Hydrogen Station Compression, Storage, and Dispensing Technical Status and Costs

Independent Review
Published for the U.S. Department of Energy Hydrogen and Fuel Cells Program

G. Parks, R. Boyd, J. Cornish, and R. Remick
Independent Peer Review Team

Subject: Independent Review Panel Summary Report

Figure ES-2. CSD cost sensitivities for the pipeline scenario

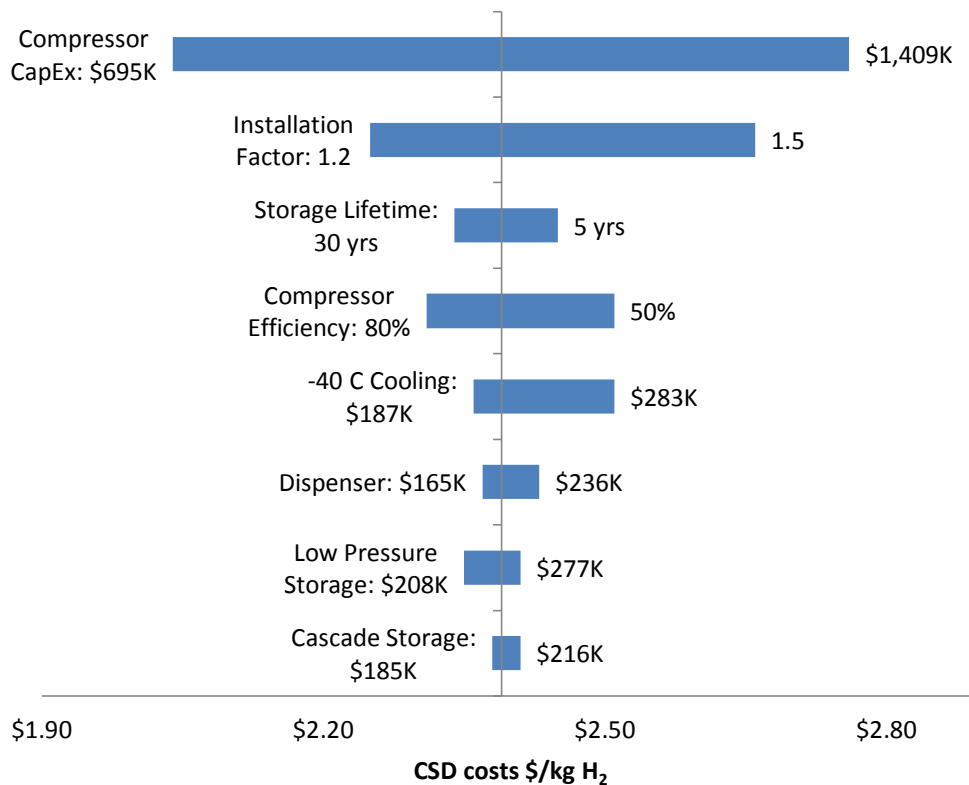
The tornado plot in Figure ES-2 shows sensitivities for the principal variables studied. Large uncertainties in compression capital cost and efficiency had large impacts, whereas the installation factor—the ratio of installed capital costs to uninstalled capital—had a surprisingly strong impact on CSD costs.

The panel identified several promising research areas. As shown in Figure ES-2, improvements in compressors, storage, and hydrogen gas cooling have the largest potential impact.

Figure 1. Schematic of the HDSAM pipeline scenario CSD

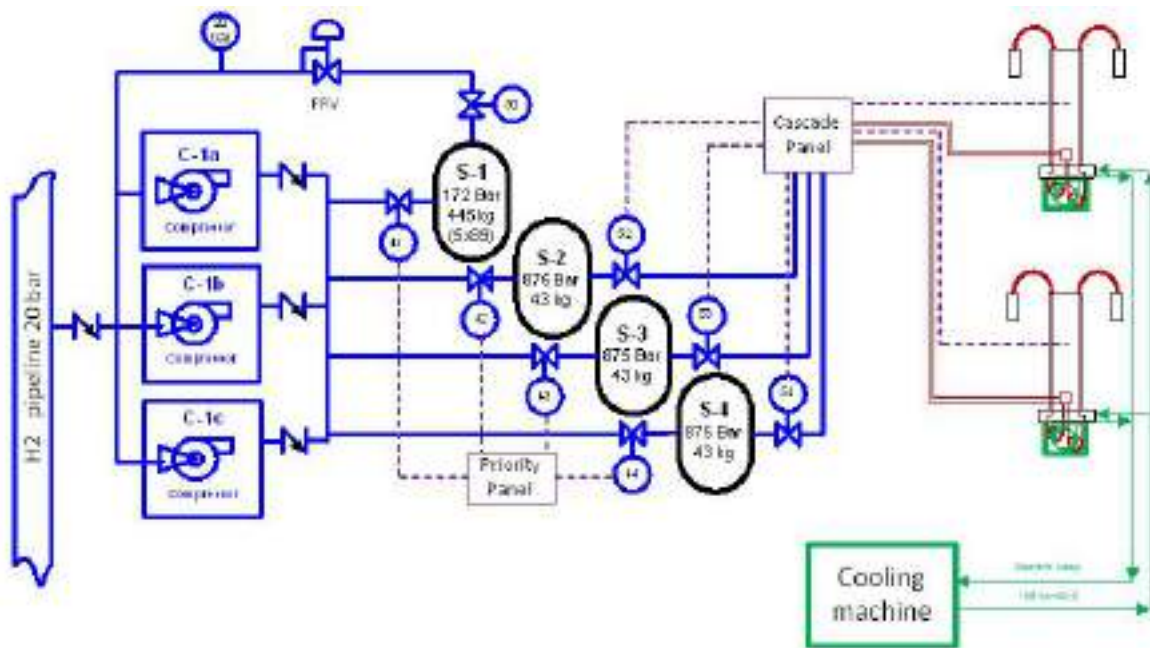
InFigure 1, storage S-1 represents the five low-pressure (172-bar) storage cylinders in the low bank; S-2, S-3, and S-4 represent the three-bank 875-bar cascades, each with two tubes. During peak operation, when hydrogen demand exceeds the rate of supply from the pipeline, the compressors draw additional hydrogen from the low-pressure storage cylinders, S-1, through valve 50.

- The fueling protocols for 700 bar require cooled hydrogen dispensing and yet still require temperature compensation for vehicle tank heating during fueling and thus a minimum of 800 bar supply to the dispenser, yet the HDSAM/H2A models uses a 760-bar low level for the high cascade bank, and thus were not able to provide complete fills during peak dispenser use times.

- The compressor system did not accommodate both the need to operate continuously to match production of hydrogen and the intermittent need to boost the high-pressure cascade system in response to dispenser demand cycles.

The panel recommends that DOE reassess the necessary forecourt CSD configuration required to support 700-bar dispensing, and that the HDSAM and H2A models be revised accordingly. The principal CSD system elements that will be affected most in such a reconfiguration are the compressor and storage systems. Based on interviews and experience, the panel describes configurations typically found in current stations employing cascade filling of vehicles as examples of possible alternatives (Section 5.1.1.1 and Section 5.1.1.2).

Figure 6. Hybrid H2A cascade system

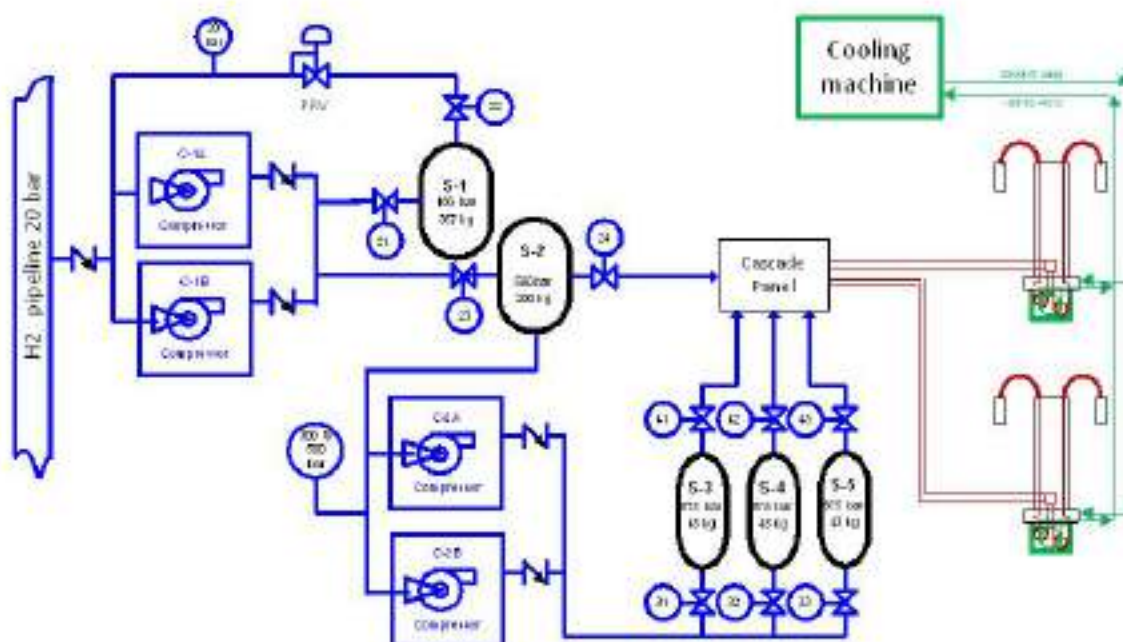
The first revised 700-bar station configuration considered by the panel utilizes a hybrid cascade system with one large 500-bar bank and dual booster compressors that supply the three 875-bar cascade buffers. This is shown below in Figure 6.

There are good reasons to break the compression into two steps, in addition to the lack of availability of one compressor that can go from 20 bar to 950 bar. Figure 6 also shows the use of a 400- to 500-bar intermediate storage bank that can be connected to the cascade panel. Starting the fueling event from the 500-bar bank reduces the total energy cost of compression.

The availability of cost-effective intermediate pressure storage vessels in the 250- to 500-bar range matches well with existing compressors and can result in large savings for intermediate storage. For example, the panel identified currently available Type 1 vessels rated at 250 bar, compared to DOE's station configuration, which assumes an intermediate pressure of 172 bar. Raising the pressure from 172 to 250 bar increases the amount of hydrogen stored by 38% at no additional vessel cost. The panel also found currently available Type 4 vessels operating at 500 bar; these can store almost 2.5 times more hydrogen than the same vessels at 172 bar. To determine the effect of using vessels at these higher pressures, the existing models would need to be reoptimized to assess the impacts on total vessel volumes and hydrogen compressor sizing.

Figure 7. Alternative hybrid configuration

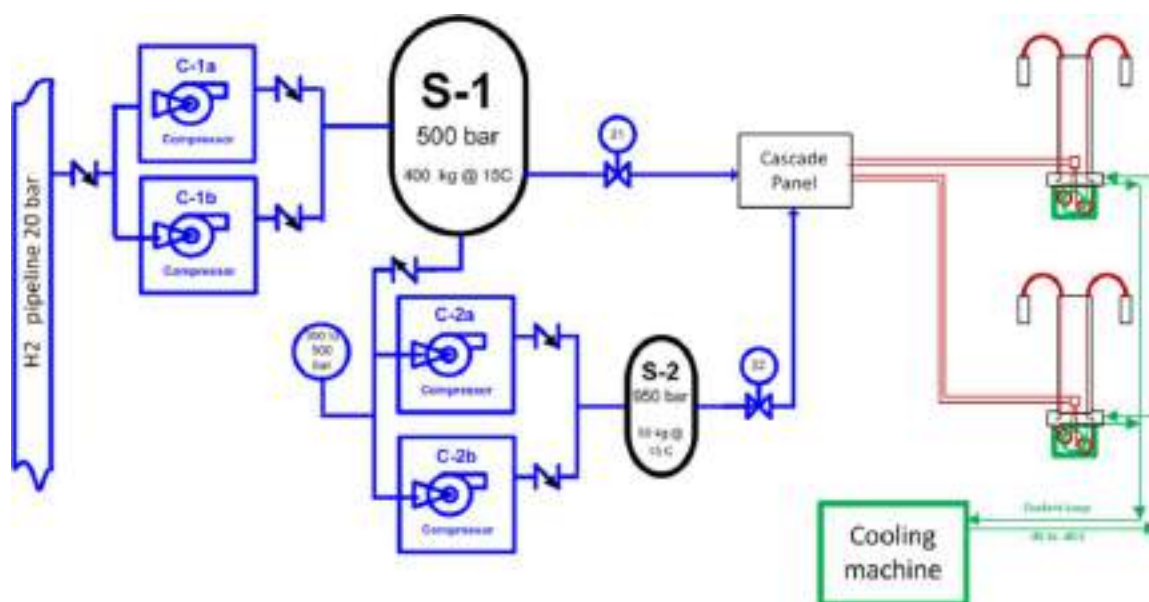
For simplicity and with lower control system cost, the hybrid cascade system depicted below in Figure 7 shows only one large 500-bar buffer and a smaller buffer at 950 bar. A minimal station design without backup compressors has been used for the Berlin Holzmarkt Straße 700-bar fueling station and a similar design with a four-bank 450-bar cascade and booster with small 950-bar buffer was installed as the upgrade of the DOE, CARB, and SCAQMD–funded station currently operating at Burbank. Note that both the Burbank and Holtsmarkt Straße stations have only one dispenser and only single compressors for each stage, Figure 7 shows this concept for a 1,000- to 1,400-kg/d station shown in the H2A/HSDAM models.
